SUBJECT: **Invitation for Bid # 10-0642-DS**
Oneco Terrace, Sunniland and Kirk Haven Water Phase 2
(Project No. 6025570 6.2)

ADDENDUM # 3

Subject: Responses to Pre-Bid and Bid Questions for Oneco Terrace Phase II

ONECO TERRACE WATERLINE REPLACEMENT (PHASE II)

VERIFY SCALES	JOB NO.
BAR IS ONE INCH ON ORIGINAL DRAWING	7880D.10
0 1" IF NOT ONE INCH ON THIS SHEET, ADJUST SCALES ACCORDINGLY	DRAWING NO.
	P-10
	SHEET NO.
	10 OF 14

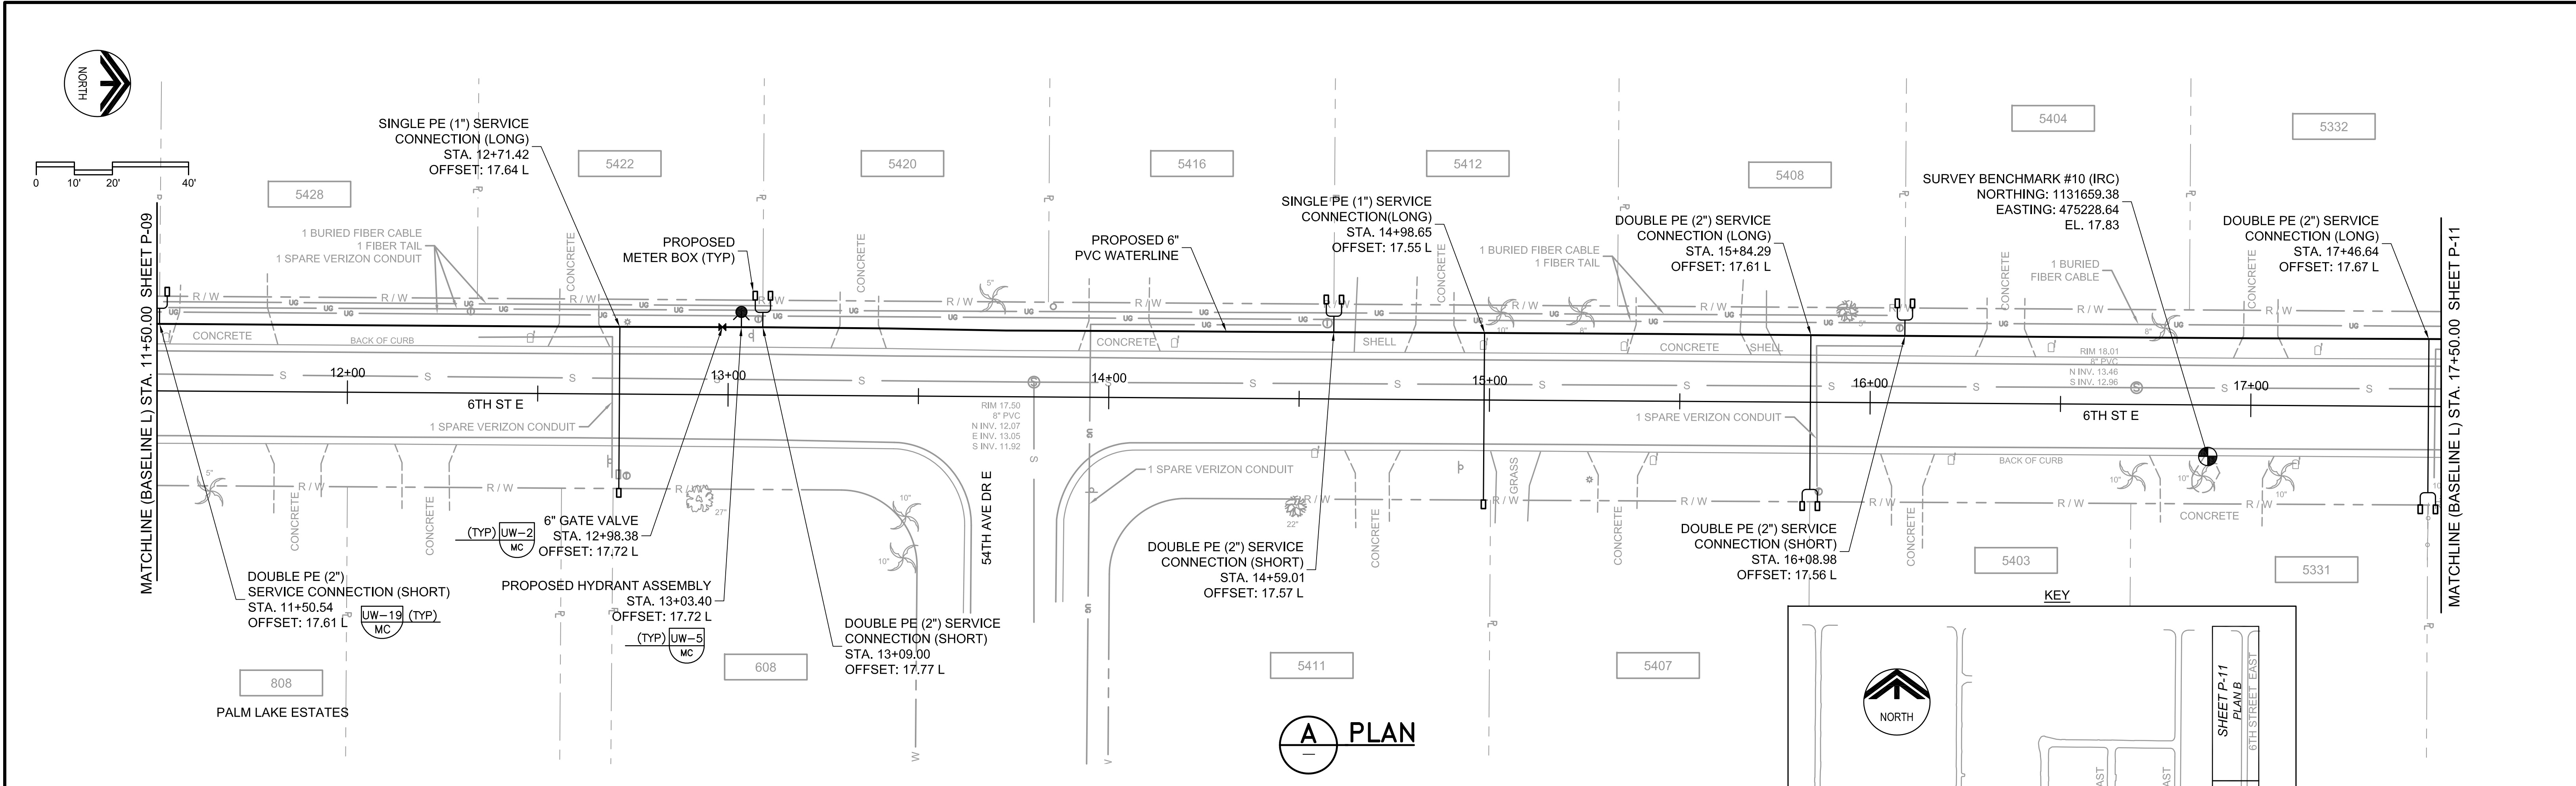
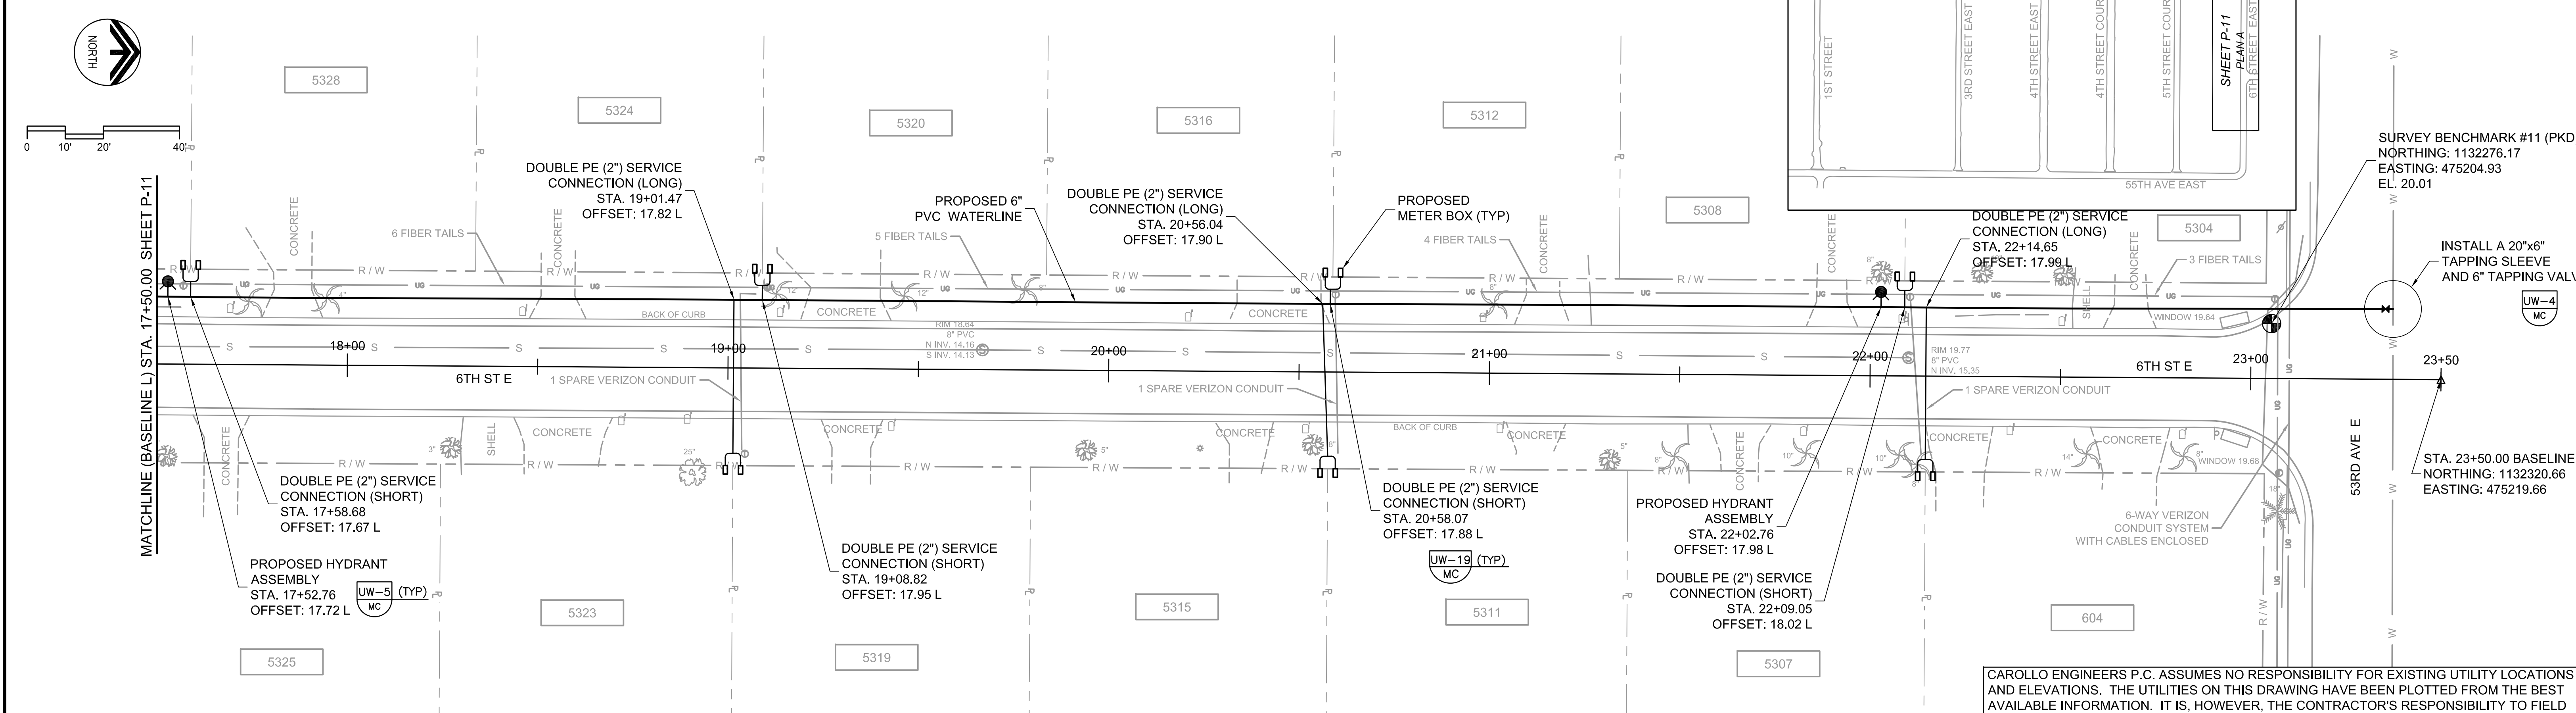
2. Sheets 4, 8, 9, 10, 11 of the plan set show Double PE services (short). There is no pay item for this service connection.

A bid item has been added for short side double PE services and quantities have been adjusted accordingly on the Bid Form.

RESTRAINED LENGTHS FOR DIP UG-9

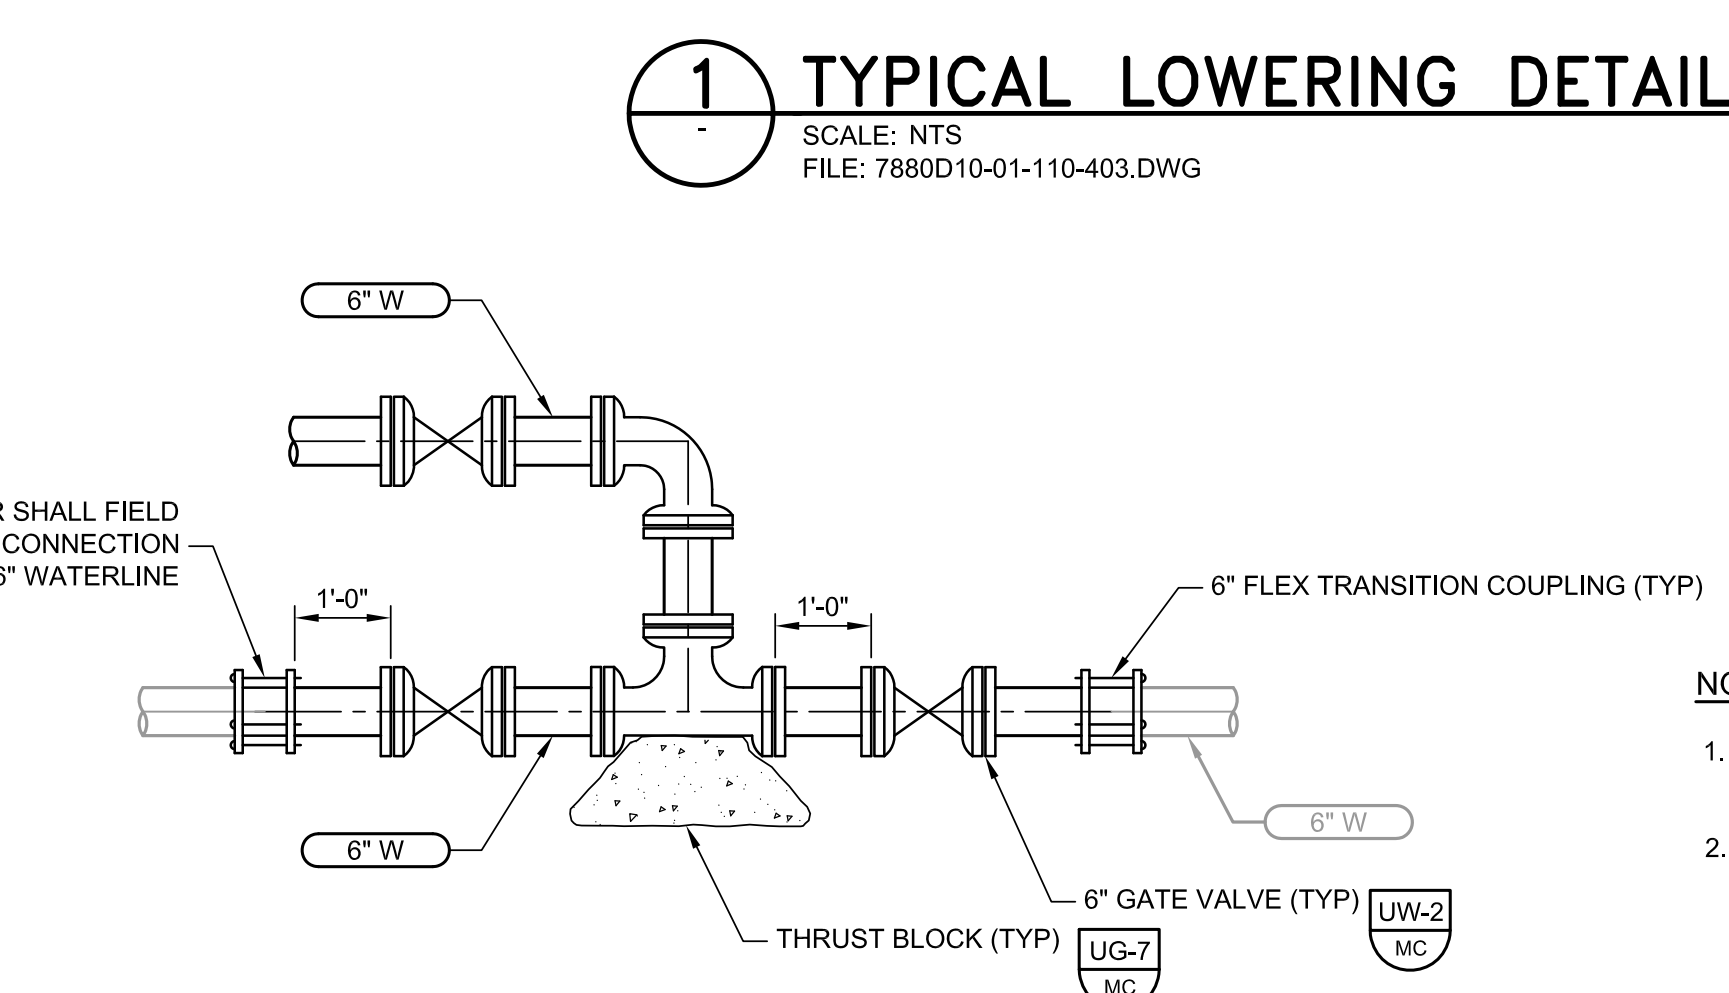
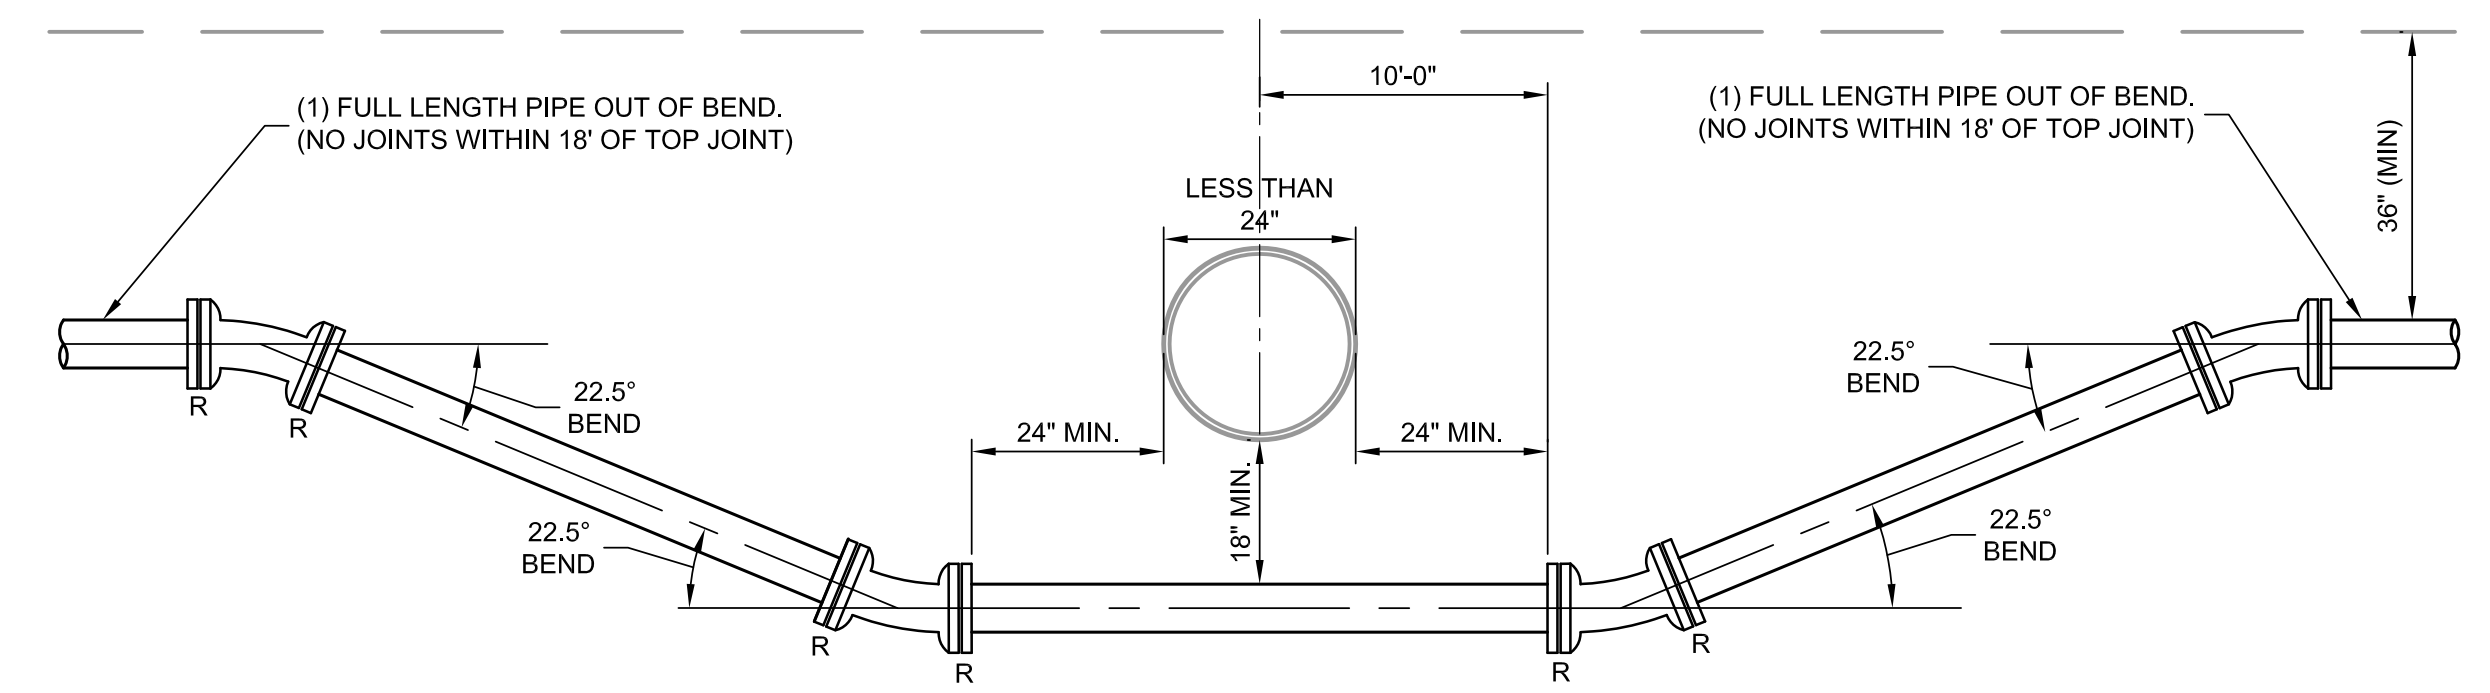
21. I would like to submit the following questions for clarification
a. I did not see a restrained joint table for this project in the dwgs. Am I to assume all Ductile Iron pipe joints are to be restrained or will restrain be accomplished with thrust blocks.

Thrust restraint shall be either cast-in-place concrete thrust blocks or restrained joint pipe lengths. The drawings have been revised to include the Manatee County typical details (UG-7, UG-8, YG-9 and UG-10) for thrust blocks and restrained pipe lengths for ductile iron and PVC pipe.
